Delegated Report

Householder Planning Application

Planning Application No: 20260152

Description: Installation of replacement windows at ground and first floor level to front elevation.

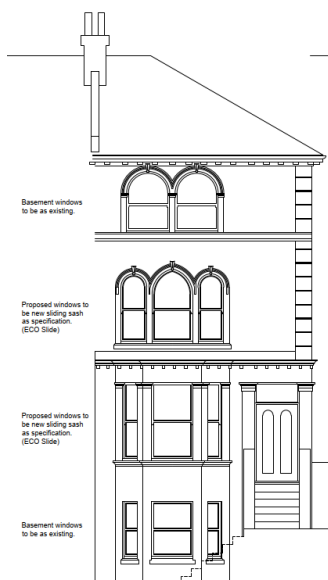
The original windows which were removed without the benefit of planning permission can be seen in Google Streetview imagery from December 2020 as follows:

(No. 27 is to the right)

The ground and first floor windows which were removed appeared to have been the original windows - timber, single glazed sliding sash windows. The issue with the uPVC, double glazed casement windows which have been installed is in summary:

- The casement opening is completely at odds with the sliding sash windows removed and those still remaining at second floor level and in the windows in the neighbouring semi no. 25;
- The windows at first floor level having a straight head and not following the rounded arches of the window openings they sit within;
- The trickle vents are an unauthentic feature and the windows have no horns which the previous windows had;
- The window proportions are thick and chunky much more so than the previous timber windows, as evident from the thickness and depth of the frame and the lower opening panes sitting much further forward than the rest of the window creating further chunkiness; and
- The windows are of thick double glazing of the 4-20-4 arrangement.
